ZONING ADMINISTRATOR'S REPORT
 VARIANCE APPLICATION
 102 N. Brearly St.

Project Description: Petitioner requests accessory building placement, setback and Usable Open Space variances to construct a 12' x 22' detached garage with a second-level open deck. Proposed garage replaces an existing 10.2' x 18.2' dilapidated garage, and includes a roof deck level feature with spiral-stair from grade to the roof deck.

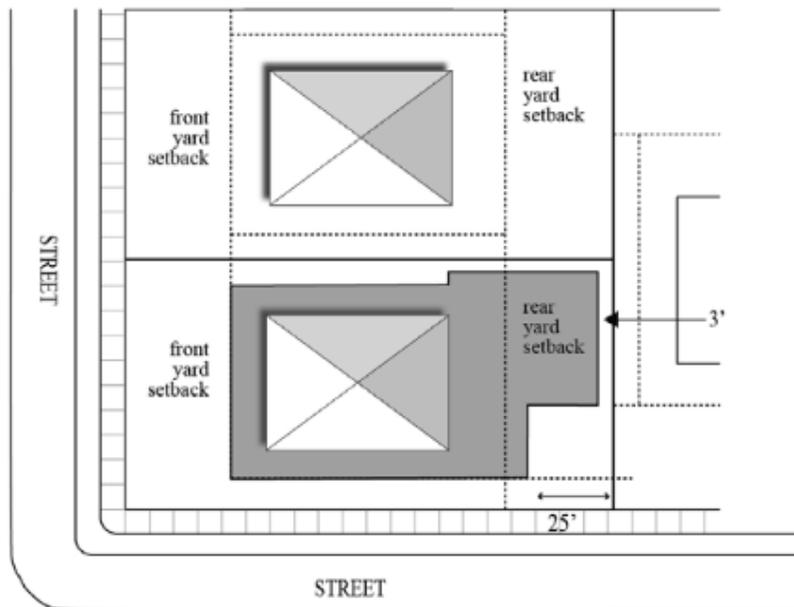
In consideration of this request, the UOS requirement is intended to provide the occupants of the building with on-site areas at the ground-level for outdoor recreation and use. The roof area does not qualify as a UOS in this zoning district. The new garage reduces the UOS provision through the expanded garage width, and the proposed spiral stair further reduces the UOS by about 130 sq. ft. Consuming a small amount of UOS for a slightly larger footprint weighs the balance between needs of parking and storage, and the provision of UOS on a lot. Consuming the UOS for the desired roof deck is not consistent with the intent and purpose of the UOS provision.

In consideration of this request, the *lot line setback for detached accessory structures* is intended to provide minimum buffering between buildings on a lot, generally located behind the principal structure on a lot. The proposed placement improves the existing condition, where the structure is actually across the lot line, but does leave little room for maintenance of the structure (see recommended condition below). The placement also maintains access to the garage by a vehicle and minimizes the loss of UOS by shifting the garage less into the yard. The proposal matches the existing setback to the west and increases to 1' on the north, but generally maintains the status quo and is consistent with what the City has found for detached garages on the end-blocks lots in this area.

In consideration of this request, this restriction is intended to ensure that a detached accessory structure does not get placed in front of the adjacent home, for the first 25' of the rear yard area and building envelope of the subject lot, or, at a minimum, will be placed at the minimum front setback required for the home to the rear, if the home is placed behind the minimum front setback. The home to the rear, the home which the reverse-corner setback is intended to protect, provides a similar front yard setback as the proposed garage. The proposed placement of the detached garage is about 38' from the home to the rear (west) and would have little impact on the neighboring home. However, the property to the rear appears to have a space open for a future new home, and this garage could be as close as 4.3' or so from the new home.

Other Comments: The project includes a roof deck access spiral stair. This stair occupies an area which results in disqualifying a UOS area, because the minimum dimension around this stair that connects to a UOS area is less than 6' in width. Eliminating the stair increases the provided UOS by about 130 sq. ft. (380 sq. ft. provided, 370 sq. ft. variance).

The garage provides a very small setback to the property lines. The placement leaves little room for maintenance of the structure. In situations where less than a 2' setback is being requested which would result in challenges in maintaining the structure, the ZBA normally requires the following condition of approval: *the petitioner must secure and record a maintenance agreement between the subject property and the properties to the north and west.*

If the ZBA does not approve the roof deck, a redesign to a pitched roof is likely. Staff would not oppose a pitched roof design. The ZBA could provide staff and the petitioner guidance to allow a conventional roof pitch with gutter system, to be reviewed and approved by staff.

Garage: It appears standards have been met, therefore staff recommends **approval** of the variance requests, subject to further testimony and new information provided during the public hearing.

Roof deck portion of project: Staff recommends that the Zoning Board find that the variance standards are not met and **deny** the requested variances as submitted, subject to further testimony and new information provided during the public hearing.
